SERVICE BULLETIN

SUBJECT: COMMUNICATIONS – ACARS & CPDLC – Modify unit software (Mod 4).

This change applies to the Dlink+ w/CPDLC, hereinafter referred to as Dlink+, with part numbers shown in the table below.

Figure 4 – Mod 4 Label Marking

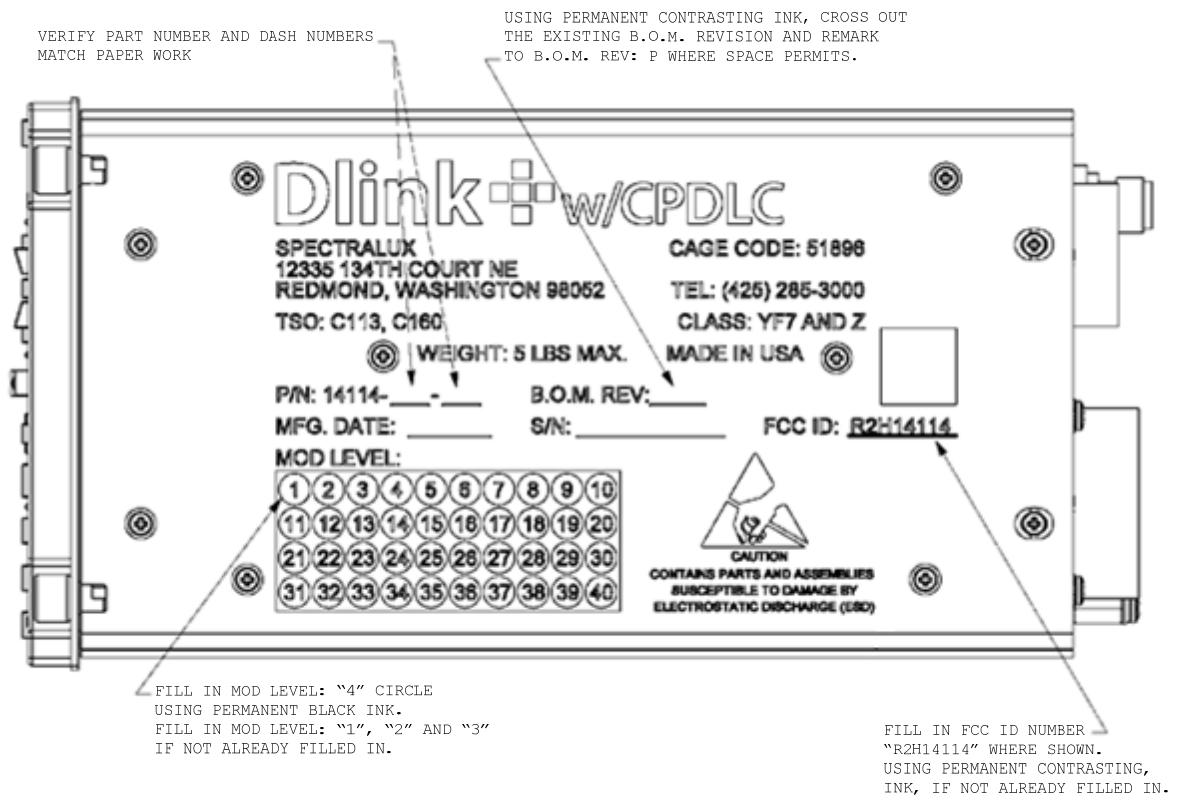
- (1) Mark the unit label according to Figure 4 – Mod 4 Label Marking.
- (2) Perform SB – 14114-23-08 or later service bulletin updating the TSAP database, if not done already on this unit.
